- Subject** ▶ Change of Switch
- For Models** ▶ JN3200, JR3000, JS3200, M101, M102, M361, M511, M515, M516, M801, M903, M992, N1900B, SR1600, SR1800, 1000SB, 1125, 1911B, 1923H, 2106, 3608B, 4100R, 4103KB, 4300SB, 4302C, 5600BR, 5600NB, 5800NB, 6013B, 63004, 6301, 6510B2, 8419B, 8419B2, 9030, 9900B, 9901, 9924B, 9924DB
- Country** ▶ See page 2.
- Description** ▶ Switch has been changed as shown below.
The new Switches don't come with four M3.5 Pan Head Screws.
Except for model N1900B, their wiring have been changed.

● **Change of Switch for Model N1900B**

● **Change of Wiring for Models except N1900B**

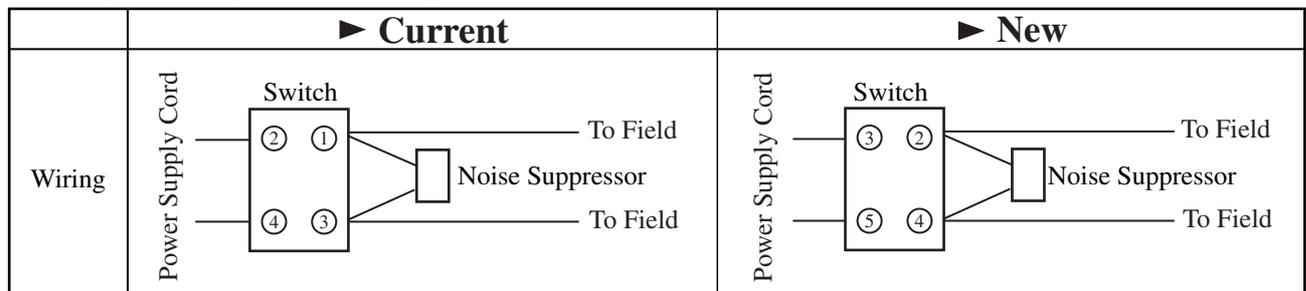
- **Noise Suppressor is not used in some countries and areas.**

▶ Current	▶ New
Manufacturer	OMRON	FUJISOKU
Cat. No.	C2M-A1T	SGEL206C
Terminal Screw	(assembled with Switch)	Pan Head Screw M3.5 x 8
Part No.	651235-2	651232-8

▶ Current	▶ New
Manufacturer	OMRON	FUJISOKU
Cat. No.	C2M-A1T	SGEL215C
Terminal Screw	(assembled with Switch)	Pan Head Screw M3.5 x 7
Part No.	651235-2	652008-6
